Cl 45 SC 45.2.4 P 47 # 1 C/ 172 P 173 L 31 L 4 SC 172.3.5 # 4 Cisco Marris, Arthur Cadence Design Systems Ran, Adee Comment Type т Comment Status D (bucket1) Comment Type ER Comment Status D fec counters "45.2.4 PHY XS registers" and "45.2.5 DTE XS registers" subsections need to be brought FEC cw counter is defined as optional in 161.6.21. Assuming it is optional here too, it into the 802.3df draft and modifications made to increase the number of service interface should be stated, as in clause 161. lanes specified from 20 to 32 Otherwise, state that it is not optional for this PCS (but I assume it's not the case). SuggestedRemedy Update "Table 45-314—PHY XS registers" and "Table 45-339—DTE XS registers" and Similarly for 172.3.6 FEC codeword error bin i. relevant sunclauses to address this. This will include an extra "XS alignment status 5" SugaestedRemedy register at location 54, adding extra "XS lane mapping" registers above 415, adding extra "FEC symbol error counter" registers above 631, and add bit 4.801,6 for "Local degraded Add "(optional)" to the subclause title in 172.3.5 and 172.3.6. SER received" Proposed Response Response Status W Proposed Response Response Status W PR

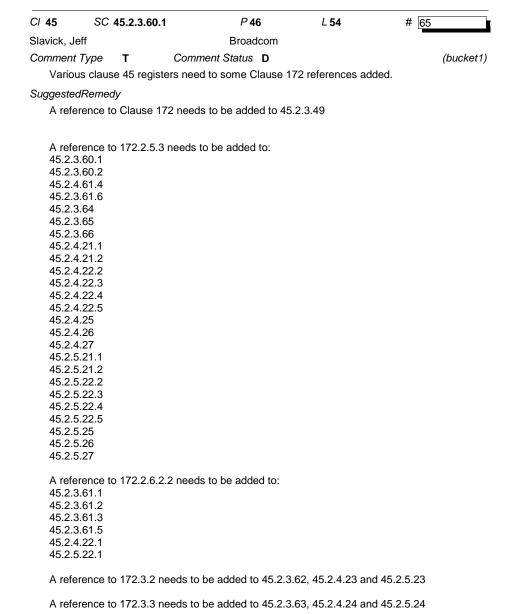
CI 172 SC 172.3.6 P173 L32 # 64
Slavick, Jeff Broadcom
Comment Type T Comment Status X fec counters

Copy of the definition of 45.2.1.131a (802.3ck) into a set of PCS registers (45.2.3.###) and replace the Clause 161 references with 172.

Replace the text in 172.2.3.6 with the same text from 161.6.17 updating the MDIO register references to point to the newly created MDIO registers.

Update Table 172-4 to point to the newly created MDIO registers.

Resolve along with comment #189.
